**Subject:** NHTSA Toyota Sienna Rampvan rear axle beam mounting (Recall Number 07V-546)

## Service Bulletin 34238

Instructions for Rear Axle Beam Assembly  
Evaluation and Securement  
Applicable for **2004-2007 Toyota Sienna  
Side Entry Rampvan® Conversions**

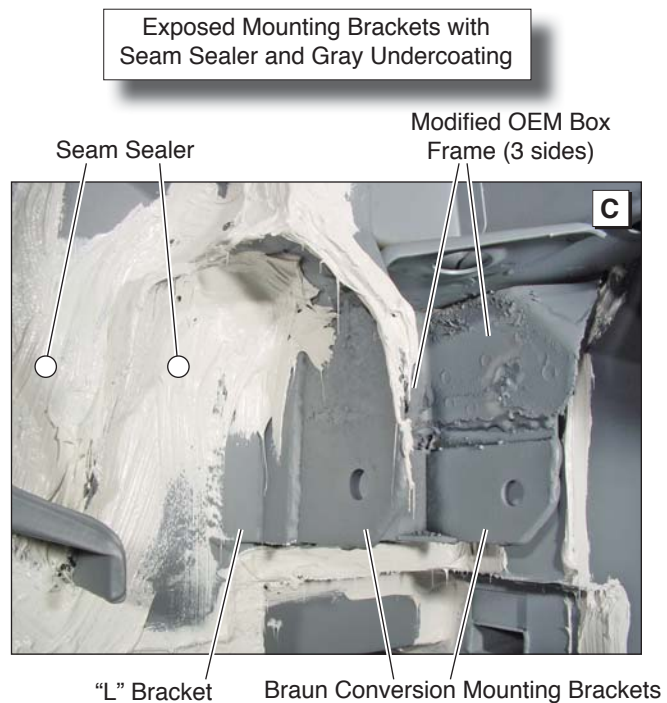
If movement is not visible but squeaking is detected, further examination is required. **Carefully** remove under coating and seam sealer from the mounting bracket area (see Photos C and D). Once brackets and welds are exposed, insert pry bar and attempt to move the mounting brackets again. If there is no

**Note:** Photo C depicts the exposed mounting bracket area with seam sealer and gray under coating. Photo D depicts the mounting bracket area without seam sealer or under coating (exposing welds).

Exposed Bare Metal  
Mounting Brackets and Welds

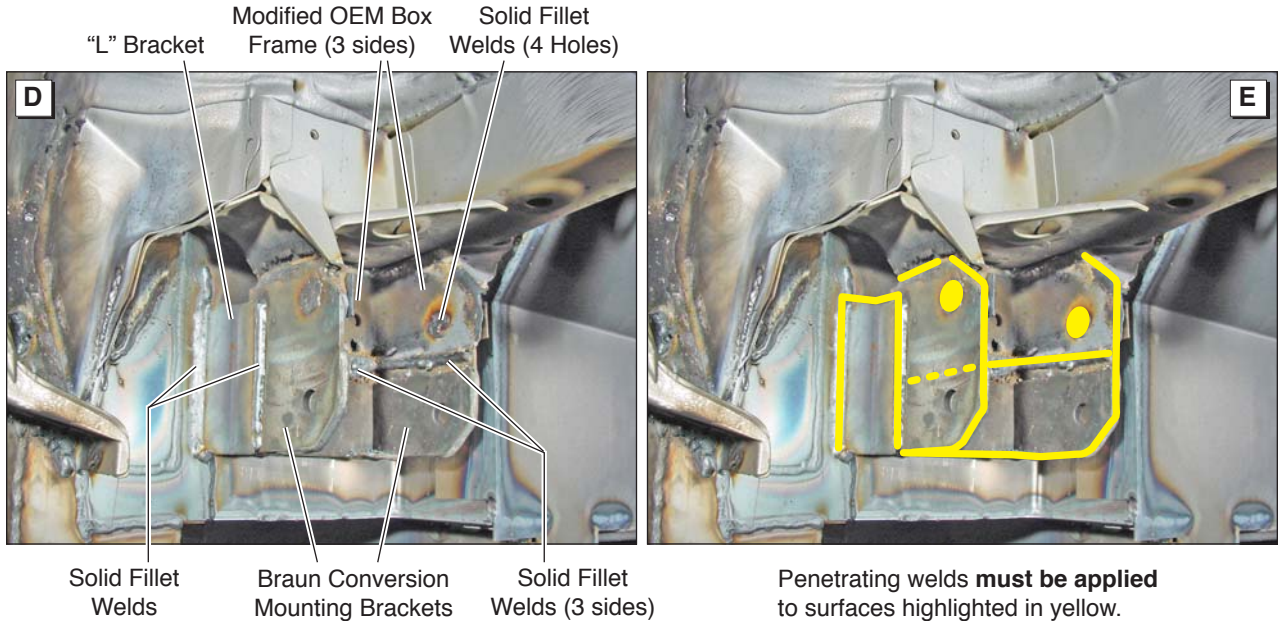
**“L” Reinforcement Bracket:** In event the “L” bracket identified in Photos C and D is not present, the bracket **must be replaced**. The “L” bracket **must** be welded into position as shown. There **must be solid penetrating welds** along both vertical edges of the bracket (see Photos D and E). **Note:** Specified welds have been highlighted in yellow in Photo E.

**OEM Box Frame-to-Conversion Brackets:** Conversion mounting brackets fit around the modified OEM box frame in a U-shape as shown in Photos C, D and E (3 sides). The holes identified in Photo D must be filled with weld (4 holes). There **must be solid penetrating welds** along the bottom horizontal edges of the modified OEM box frame.

Apply fillet welds along the edges of brackets as specified on pages 2 and 3 and shown in Photos D and E (page 3). Ensure integrity of welds.

Mounting Screws (4)  
Early Production Panel

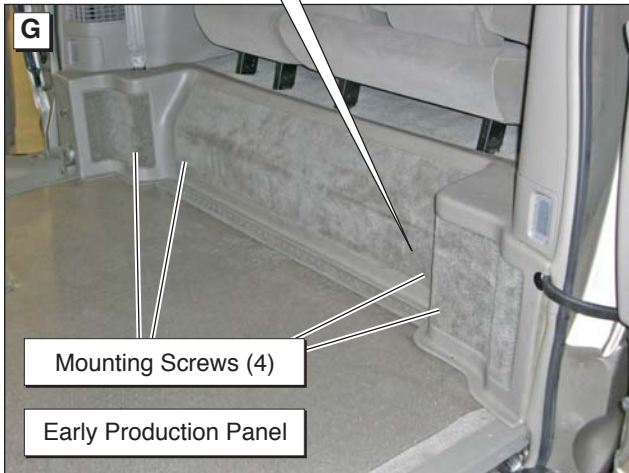
1. Remove the molded plastic panel secured to the rear vertical face of the lowered floor pan. **Note:** Two types of panels may be present (mounting hardware varies per type). Approximate mounting screw locations depicted above.

Earlier production panels are secured with four self-tapping screws (see Photo G). **Carefully** loosen the corners of the carpet to expose mounting screws (see Photo G Detail).

Newer production panels are secured with two self-tapping screws (see Photo H). Screws are inserted through the carpet (see Photo H Detail). The black headed screws can be located using a bright shop light.

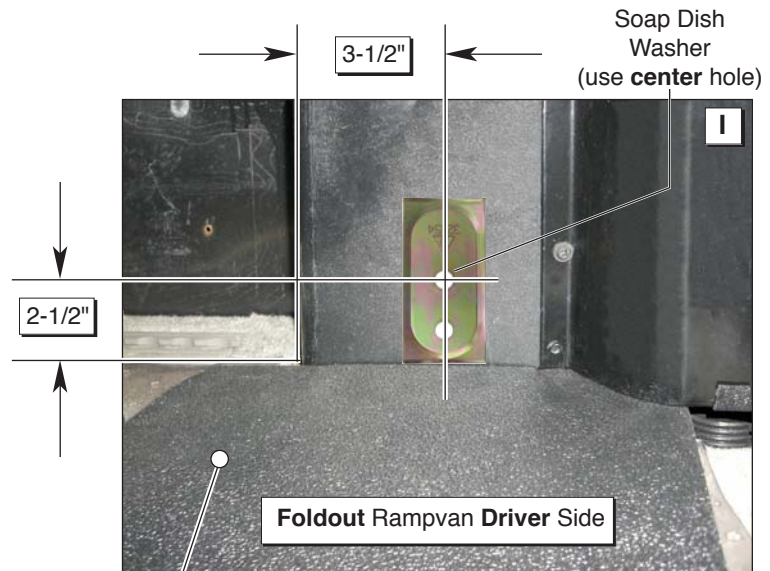
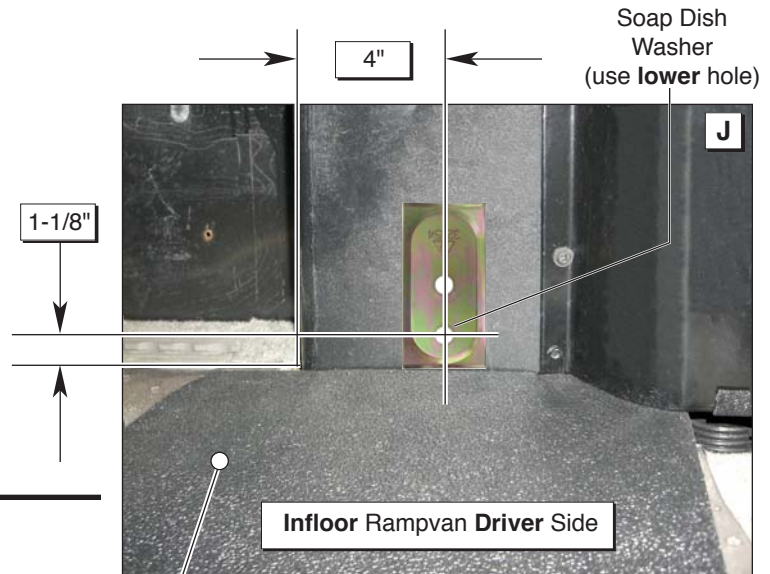
Locate **driver side** mounting bolt hole. The mounting hole location is exclusive for foldout ramp and infloor conversions. Locate hole centers as specified. Photos with dimensions are provided for each (see Photo I for foldout ramp conversions and Photo J for infloor conversions).

Center punch and **carefully** drill a pilot hole (1/8" to 1/4" diameter).

**Carefully** drill a 1/2" diameter mounting hole (watch depth).

### Infloor Only

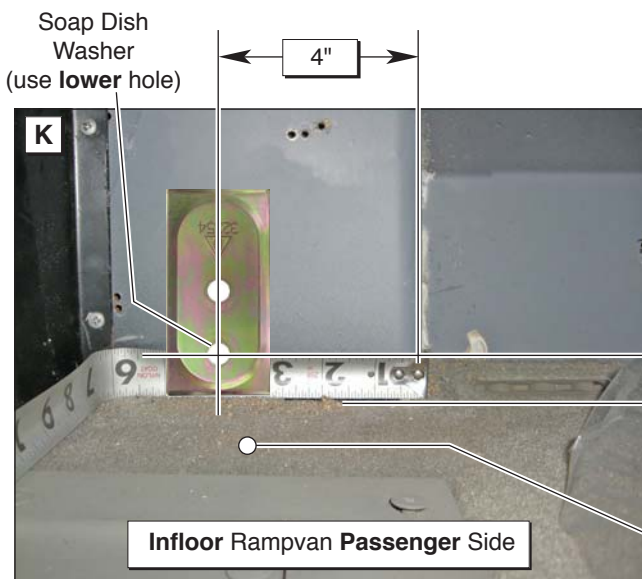
- Locate and drill the **passenger side** mounting bolt hole (**Infloor conversion only**). Locate the hole as specified in Photo K at left. Repeat pilot hole and mounting hole drilling procedures (detailed above in Step 2). Follow same precautions.

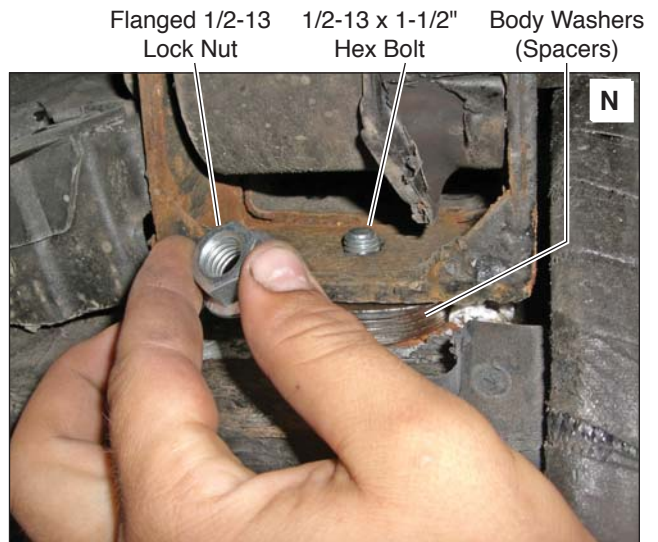
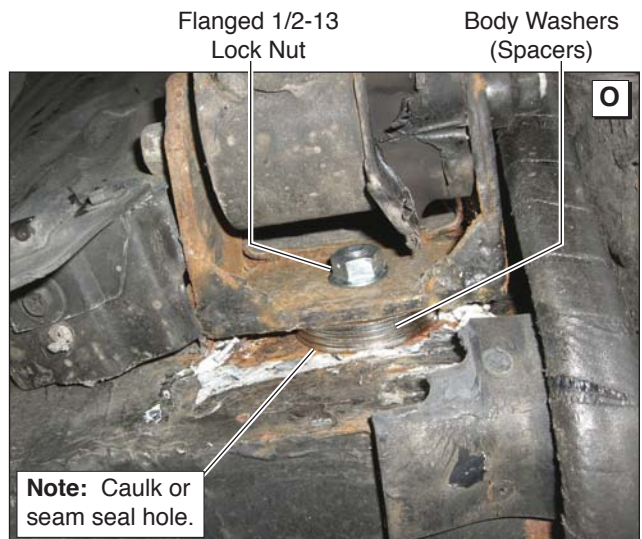
- The 1/2-13 x 1-1/2" long hex bolt is to be inserted through the soap dish washer from the interior. See Photo L. There is a gap (space) between the lowered floor pan and the rear axle mounting bracket. Five 2-1/2" diameter flat body washers are supplied for use as spacers. Insert the required number of washers to fill the space.

Insert the mounting bolt through the soap dish washer, floor pan, spacer washers and axle mounting bracket. See Photos L, M, N and O. **Note:** Apply caulk or seam seal to seal the mounting hole.

Secure the bolt with the 1/2-13 flanged lock nut (see Photos N and O). Secure the nut with a wrench from below while an assistant tightens the bolt from above. Tighten securely. **Torque Specifications:** 57-80 foot pounds.
